FORETRAVEL
MOTORCOACH

Foretravel Service Bulletin

Brake Pressure Switch Recall 26V- 486

Figure 1

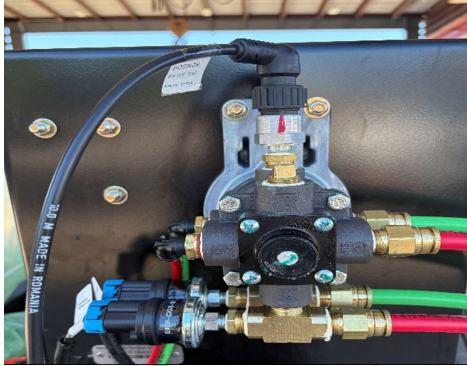
1. Verify the coach is in the current population designated by Spartan RV Chassis. Perform a visual check of the normally closed brake switch on the treadle valve of the coach. (Refer to Figure 1 and 2) Remove the carpeted panels in the pedal area to gain access to the pressure switches behind the treadle valve.
